<b>Flight Procedure Tracking Form</b>		<b>Action:</b> AMENDMENT	<b>Task Type:</b> IAP	<b>Date Open:</b> 08/24/2017	<b>Task #:</b> 2017081130263806001	<b>Request #:</b> 20170811302638
<b>Procedure:</b> COPTER NDB 303 AMDT 6B			<b>Airport ID:</b> KEOD	<b>Airport:</b> SABRE AAF (FORT CAMPBELL)		<b>Reimbursable #:</b> NO
<b>City:</b> FORT CAMPBELL(CLARKSVILLE)	<b>ST:</b> TN	<b>GPS #:</b>	<b>Estimated Chart Date:</b> 04/25/2019		<b>FICO #:</b>	
<b>Fac ID:</b> CKV		<b>Fac. Type:</b> NDB		<b>Specialist:</b> KELLY DEAN		
<b>Procedure Review</b>						
	<b>Rec'd</b>	<b>Rel'd</b>	<b>Full Name</b>	<b>Comments</b>		
<b>Lead:</b>	10/01/2018					
<b>QA:</b>						
<b>Liaison:</b>						
<b>Procedure Comments:</b>			ENROUTE	<b>Remark Type:</b> INFORMATION		
ABREV AMDT  VOR MON PROJECT - BWG VORTAC  POC FOR THIS ACTION IS DON LANIER 405-954-8242  PROCESSED IAW AIRCRAFT OPERATIONS GROUP (AJW-33) MEMO, OCTOBER 3, 2018, SUBJECT: FLIGHT INSPECTION REVIEW NOT REQUIRED

COPTER NDB 303°

SABRE AAF (FORT CAMPBELL) (KEOD)

# Federal Aviation Administration Categorical Exclusion Declaration

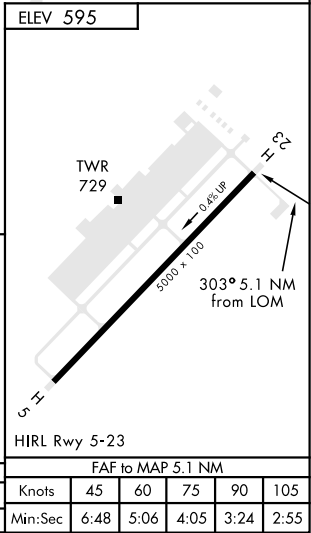
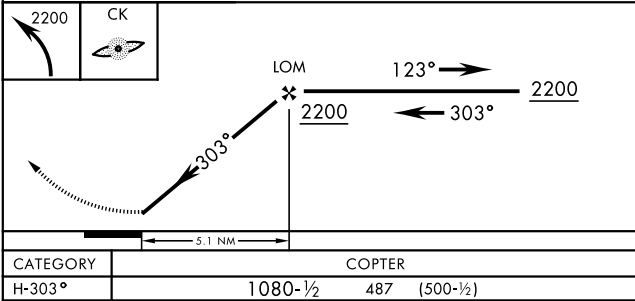
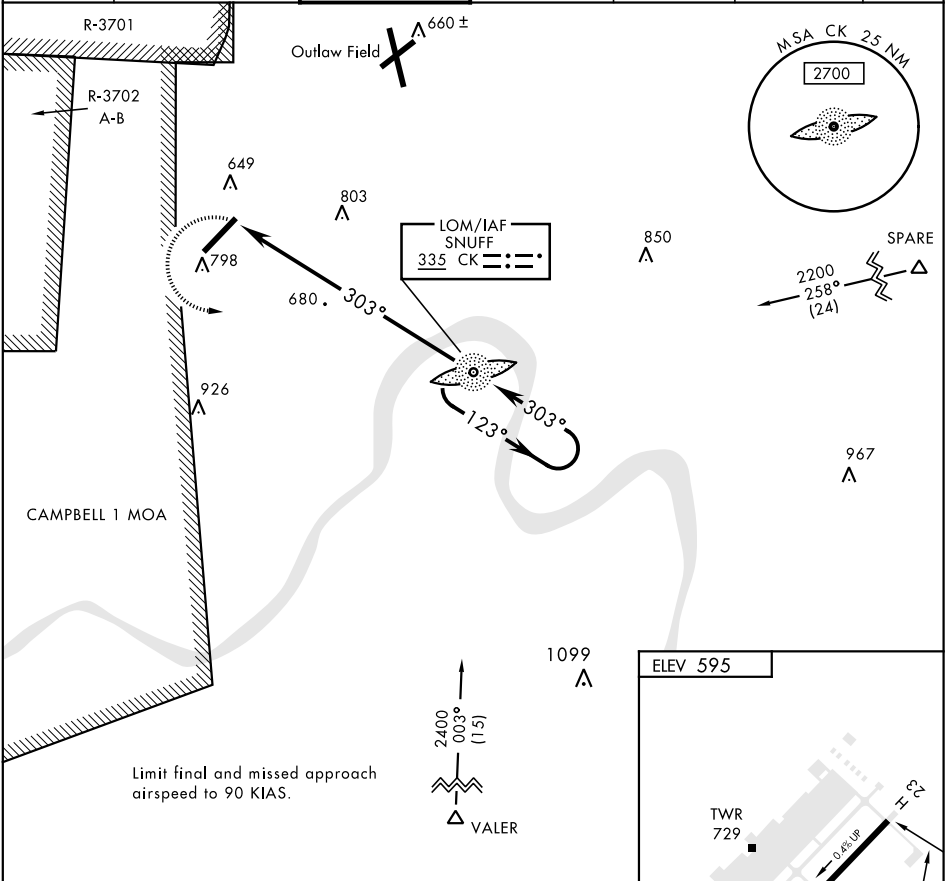
COPTER VOR RWY 23 and COPTER NDB 303° require the removal of the Feeder Fix VALER.
